**JOINT REPORT ON FLOODING, ESSENTIAL SERVICES, STORMWATER,
GROUNDWATER & EARTHWORKS**

PREPARED 19 APRIL 2024

4. The experts understand that the discussion is in respect of the proposed Iron Gates Residential Development of land at 240 Iron Gates Road, Evans Head (the **Site**).

Figure 1 – Existing Essential Energy Network & Proposed Connection Point

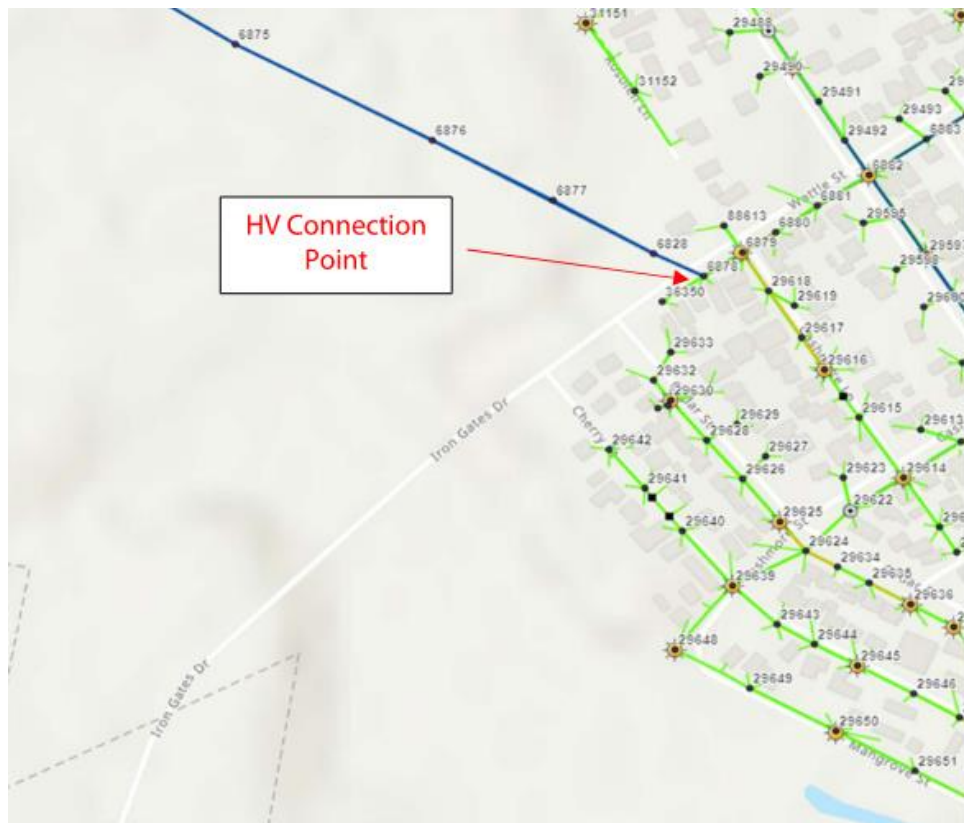
LP noted as outlined in the Engineering Services Report prepared by Arcadis and the included advice letter prepared by Preferred Energy, the proposed connection point for supply of electricity to the development is on Wattle Street, in the southern verge roughly halfway between Cedar Street and Cashmore Lane. The connection location is identified in Figure 1 below.

Following the receipt of a Development Approval, Essential Energy would formalise the design requirements after receiving a Connection Application and Design Information Application. It is expected that the infrastructure to service the development would include underground cables along Iron Gates Drive, with an underground network throughout the development site road network to facilitate the connection of new lots to the Essential Energy network.

Figure 6: Turn treatment assessment for Site Access/ Iron Gates Drive Intersection in the design year 2034

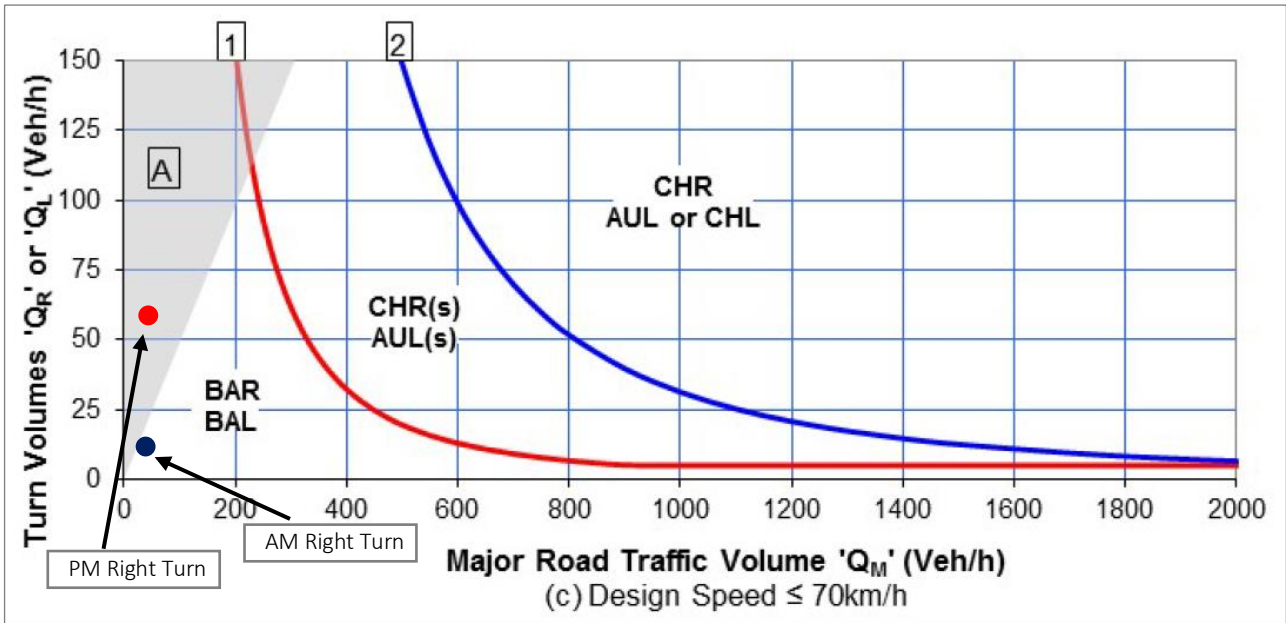
The assessment of the right turn treatment for Site Access/Iron Gates Drive, as depicted in Figure 6, indicates that a Basic Right (BAR) turn facility is sufficient to accommodate the right-turning volume at this intersection. The BAR turn facility should incorporate extra space on the roadway for through traffic movement when the lane is occupied by a right-turning vehicle. Consequently, turn treatments such as Channelised Right (CHR) are not warranted.

Figure 7: Turn treatment assessment for Woodburn Street / Wattle Street Intersection in the design year 2034

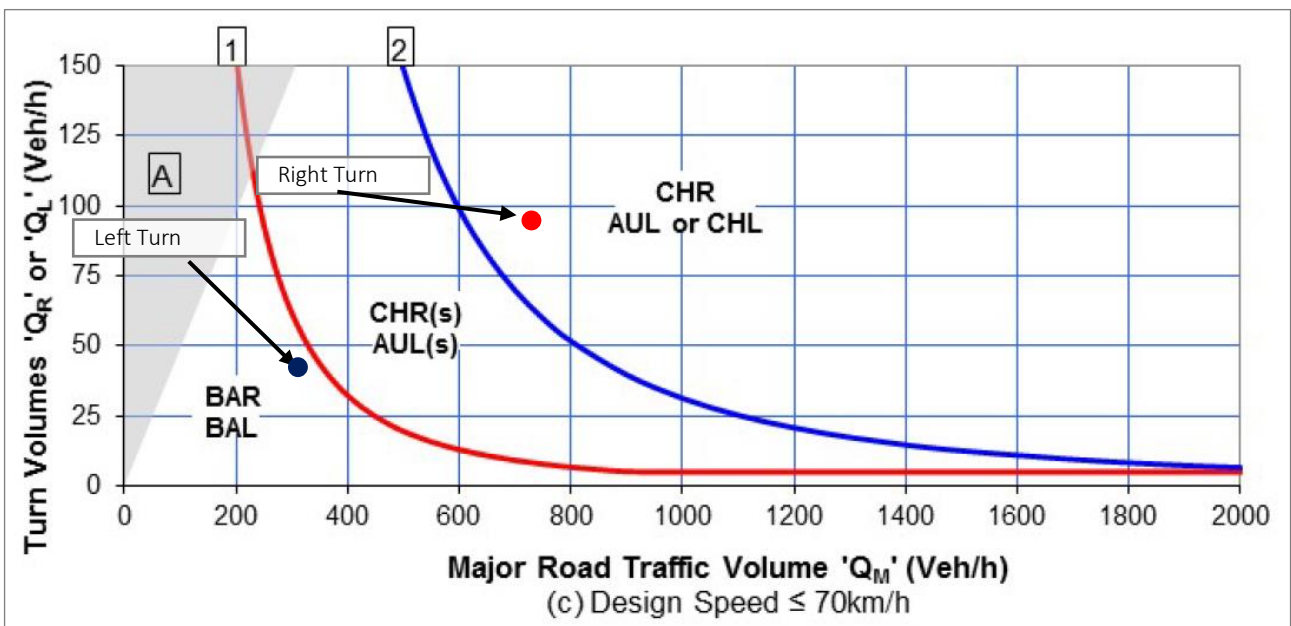
The assessment of turn treatments for right turns from southbound Woodburn Street to Wattle Street indicates the necessity of a Channelised Right Turn (CHR), while a Basic Left Turn (BAL) facility is deemed sufficient for left turns from northbound Woodburn Street to Wattle Street. TTM recommends incorporating a CHR turning treatment into the design of the Woodburn Street/Wattle Street intersection. This turning treatment is expected to be achievable through line marking and should be implemented before the completion of the development. Refer to Appendix B for the concept functional layout incorporating the required CHR treatment on Woodburn Street. As the updated concept proposal for the development (Appendix A) is expected to generate comparatively less traffic than the previous proposal, the functional layout provided in the previous traffic letter dated July 17, 2019 (refer Appendix B of this letter), can be retained.

Figure 10: Turn Warrant Assessment for Woodburn Street / Wattle Street Intersection during Bulk Earthworks

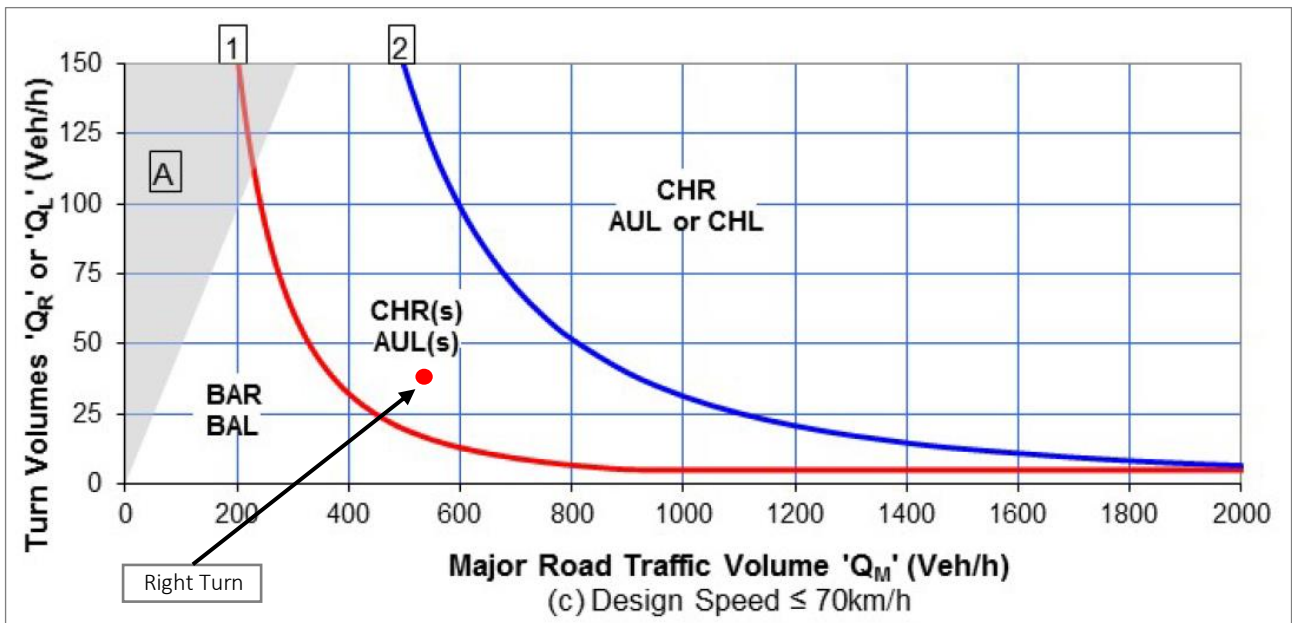
Following the turn warrant assessment, it is determined that a channelised right turn treatment is necessary for right turn movements from southbound Woodburn Road. However, the need for this turn warrant treatment is not triggered by bulk earthwork traffic but by the existing traffic conditions. Nevertheless, considering the temporary nature of the works and the resulting low traffic volume, coupled with the operational status of the current basic right (BAR) turning treatment, a channelised right turn treatment specifically due to bulk earthwork is deemed unnecessary.

| DRAWING TITLE FUNCTIONAL LAYOUT WOODBURN STREET & WATTLE STREET | DRAWING NUMBER 24GCT0055-01 | REVISION A |

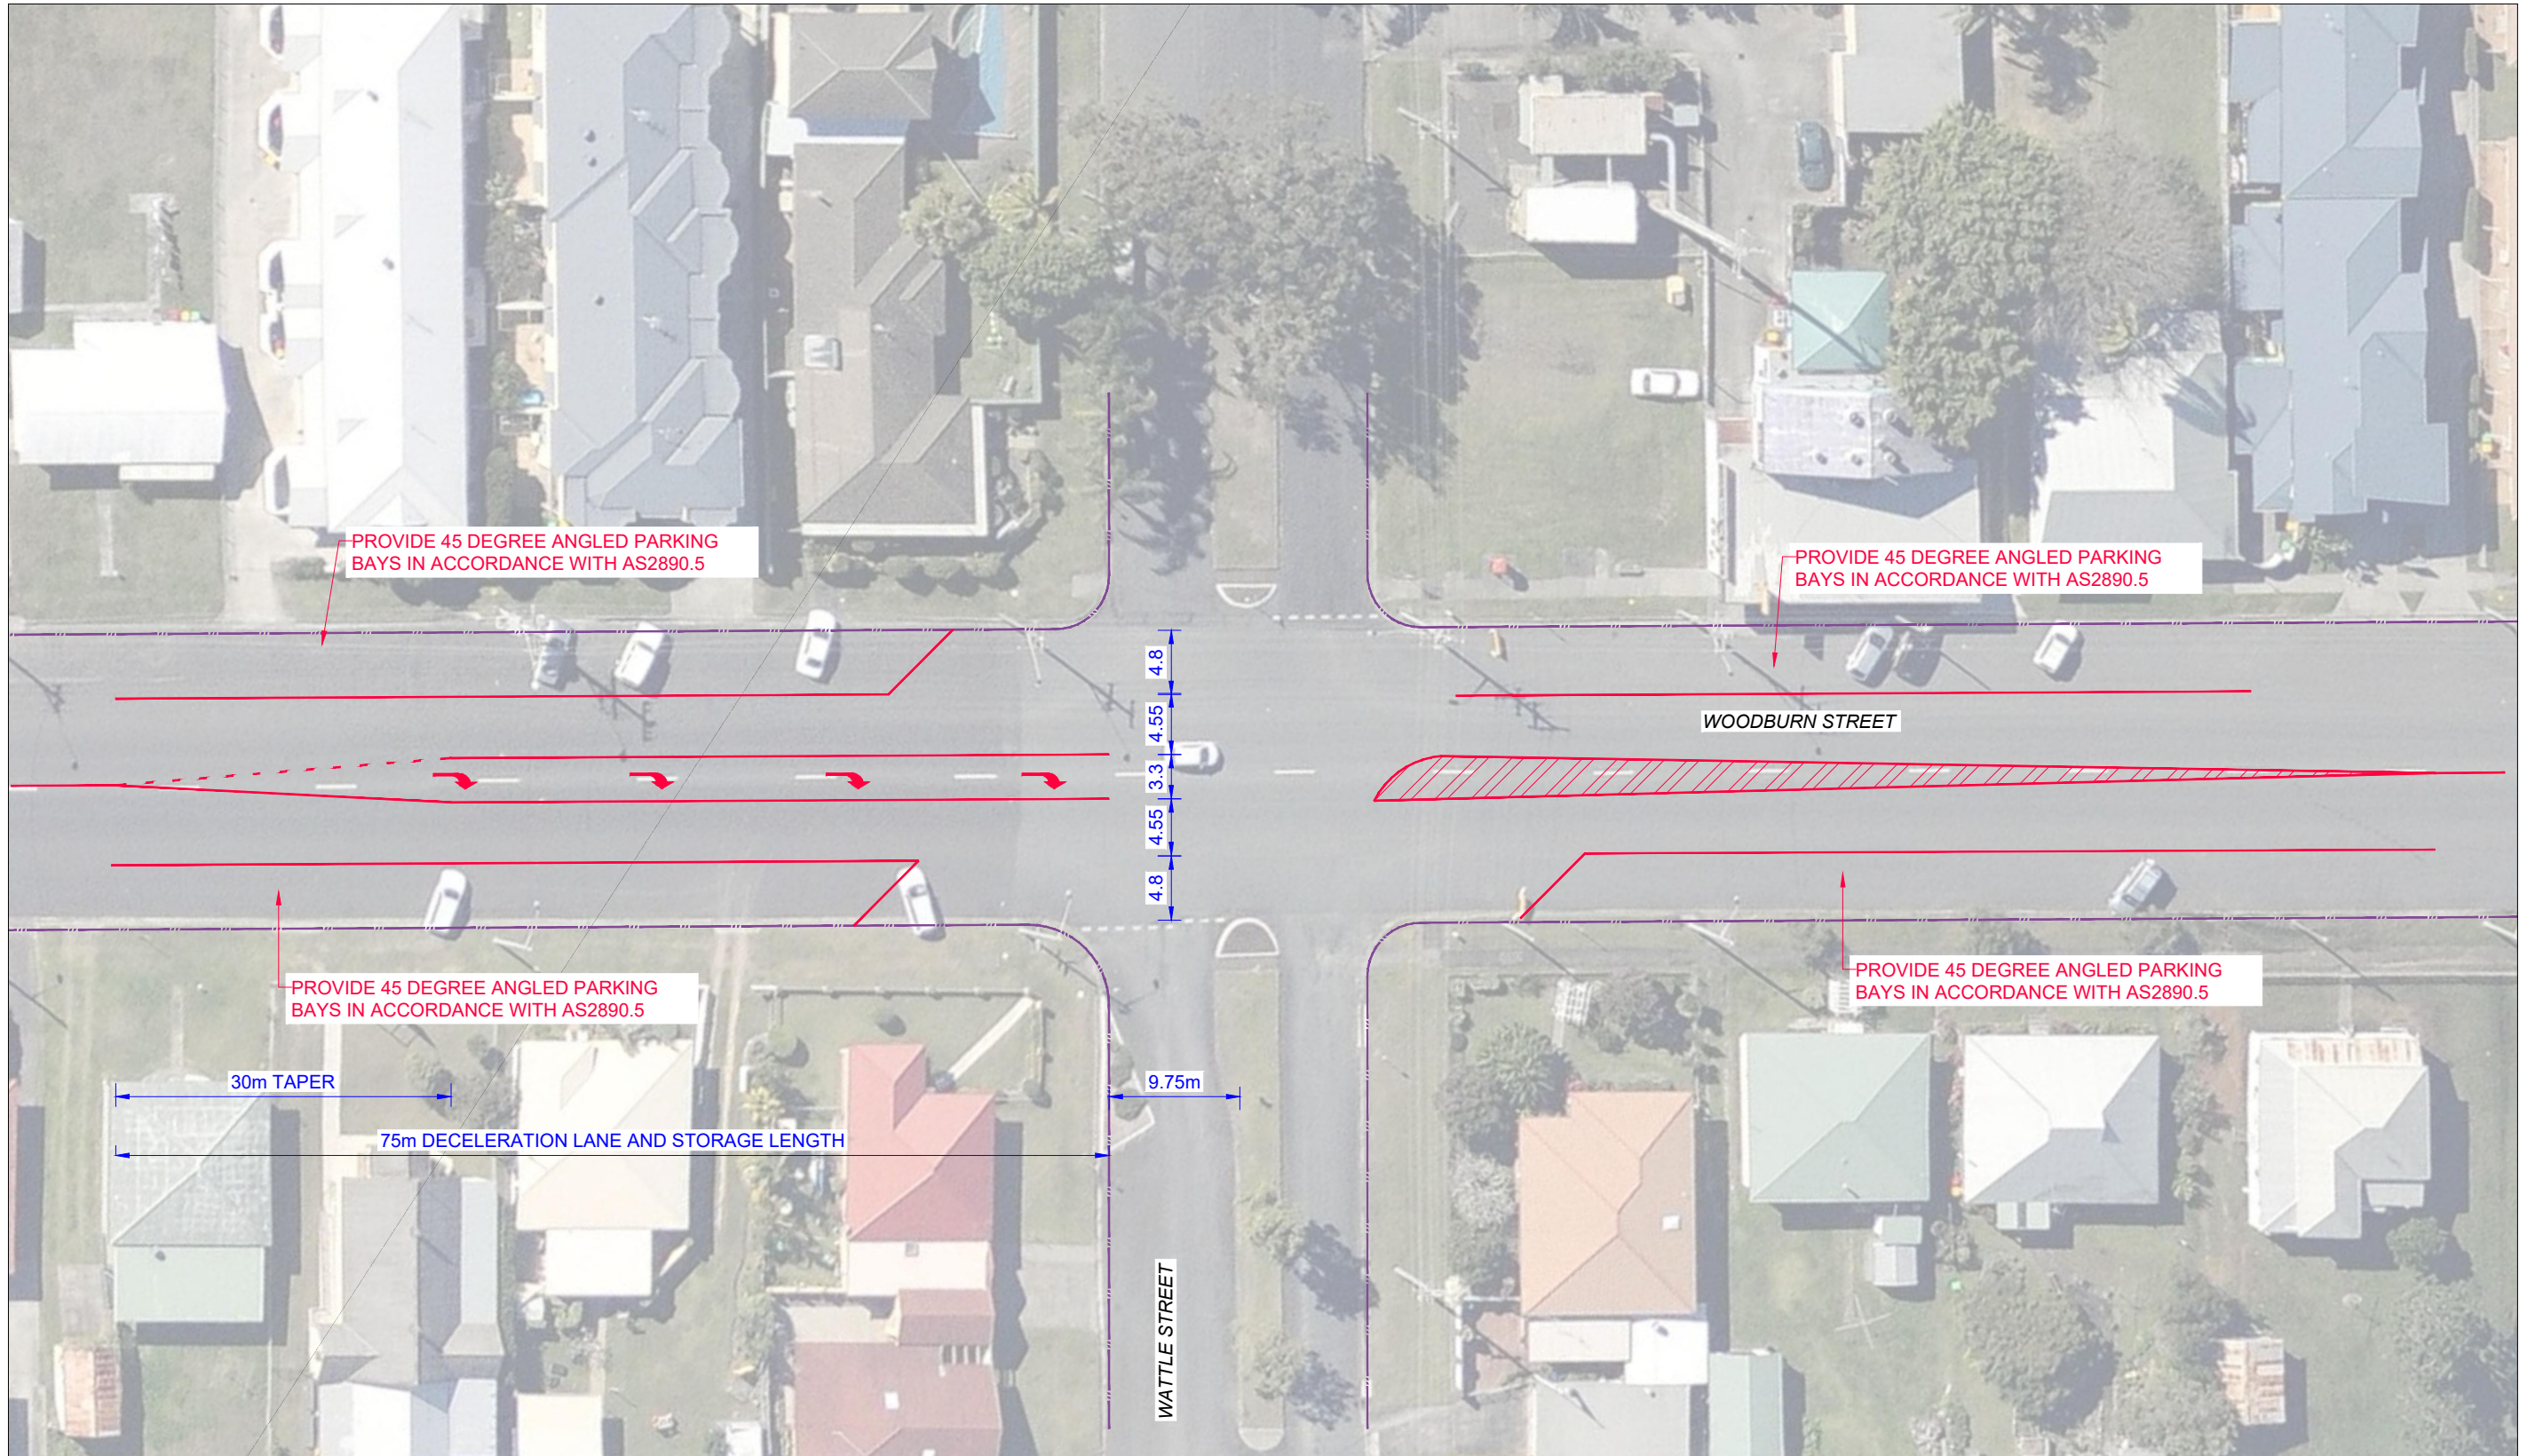
TTM recommends the installation of a channelised right-turn facility on the northern approach of the Woodburn Street/Wattle Street Intersection before the completion of the development, in accordance with the concept plan of the intersection functional layout provided in Appendix B.

Map Title / Figure:

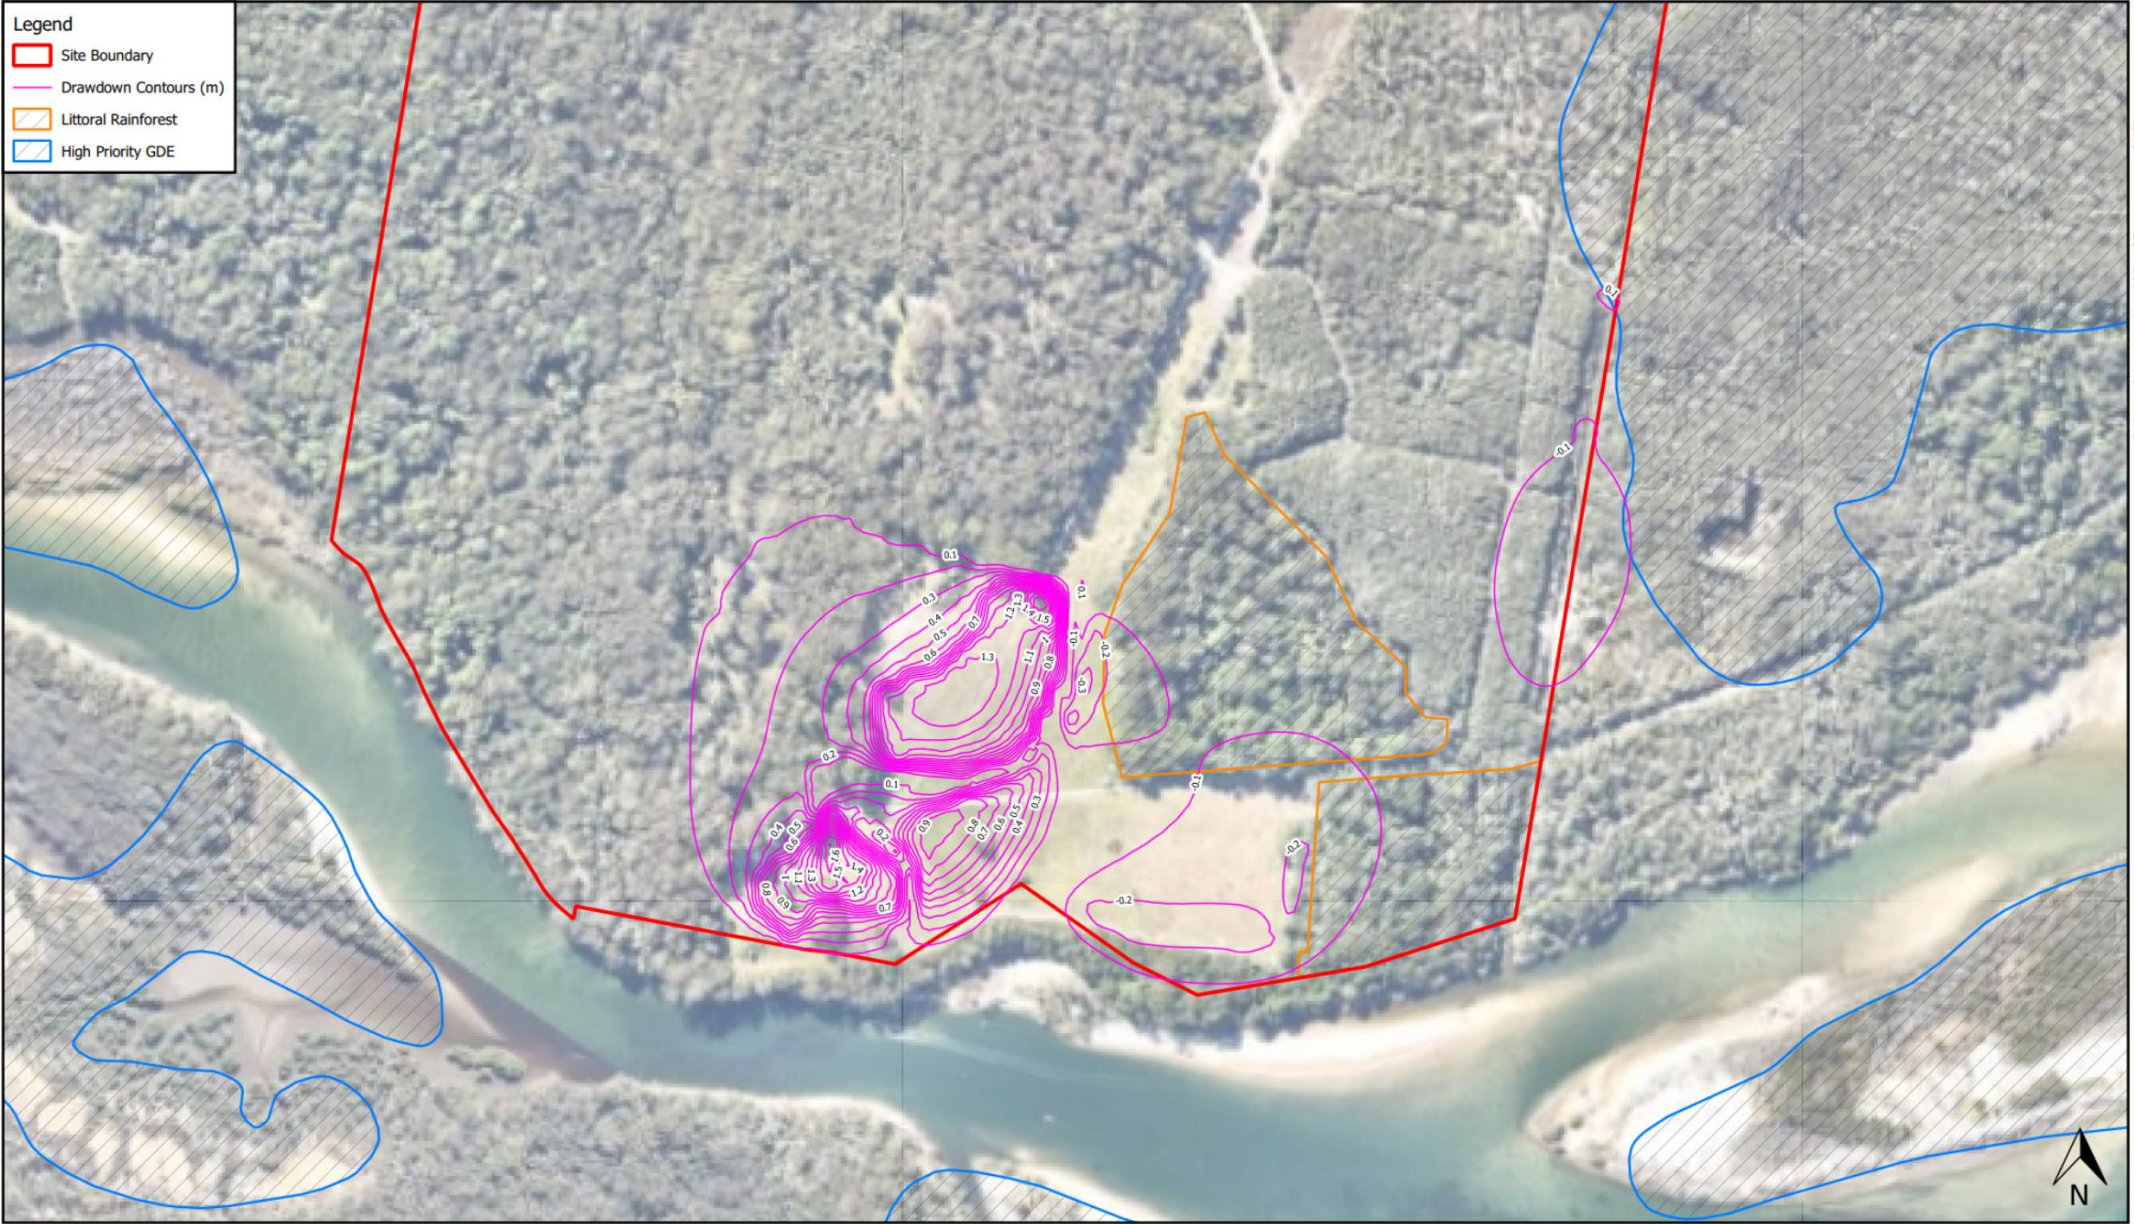
The groundwater model documented in the HIA was re-run based on the amended concept engineering plans. Amendments included all proposed bio-retention swale areas, with liner properties as follows: swale A 50 mm/hr, swale B impermeable, swale C 15 mm/hr, swale D 17 mm/hr and swale E 17 mm/hr, and revised stormwater flow rates to the bio-retention swales derived from an amended MUSIC model. A groundwater drawdown impact plot for the amended concept engineering plans is provided in Attachment D which demonstrates minimal change to existing groundwater conditions. Clause 2.8 of SEPP R&H is satisfied because:

- The projected change in average groundwater levels is very small (around 0.1 m) compared to the groundwater level variations experienced naturally within the rainforest and wetland areas, which were in the order of 2 – 5 m during the groundwater monitoring period.
- Groundwater gradients to wetlands are not expected to be materially altered, and therefore flow regimes to, and hydrological integrity of, the adjacent coastal wetlands and Littoral rainforest will not be impacted. The quantity of
